HIOKI E.E. CORPORATION

Product Recall and Repair: CONNECTION CORD L9197

Figure 1: Brake and come off condition

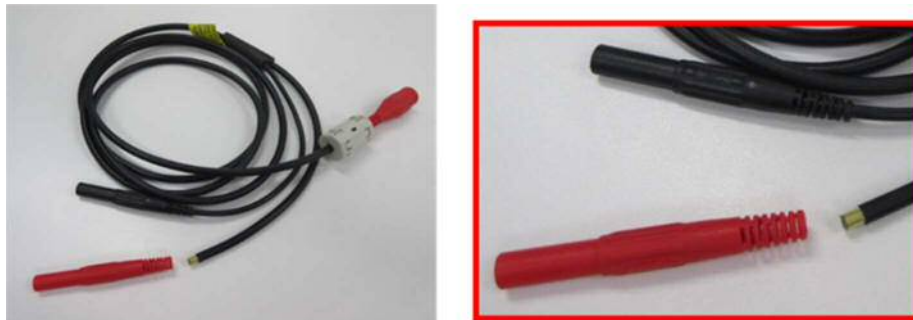
- 1. The red banana terminal of the coaxial cable may brake and come off after being used only for about 10 times (Figure 1). Two cases have been reported out of 2,231 units shipped from HIOKI, as of May 20, 2020,.

Figure 2: Exposed metal fitting

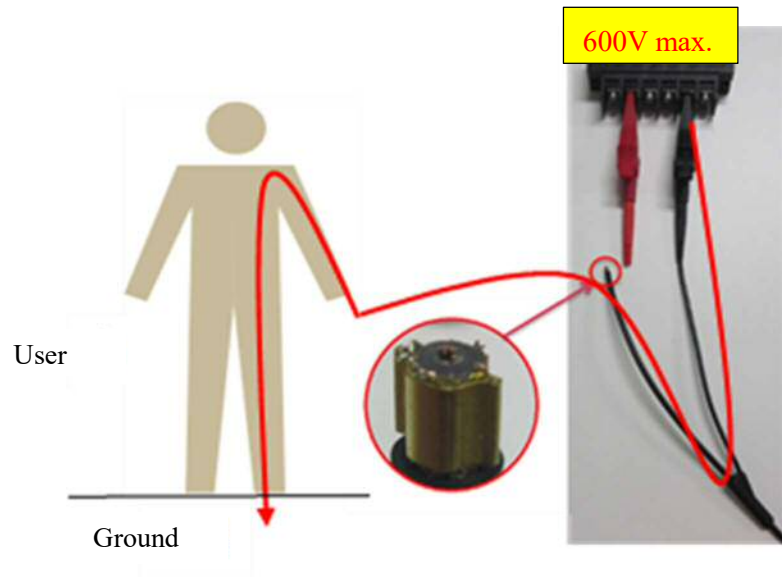
- 2. There is a risk of getting electric shock when a customer touches to the exposed metal fitting of the cut off coaxial cable while the black crocodile clip is connected to the live circuit (Figure 2).

Figure 3: Different banana terminal position

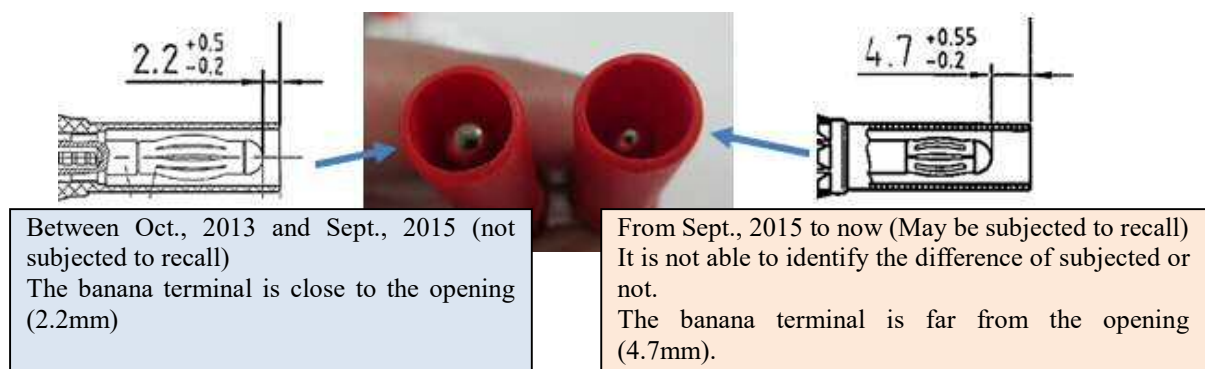
The different banana terminal position in Figure 3 may help to understand the approximate production period.
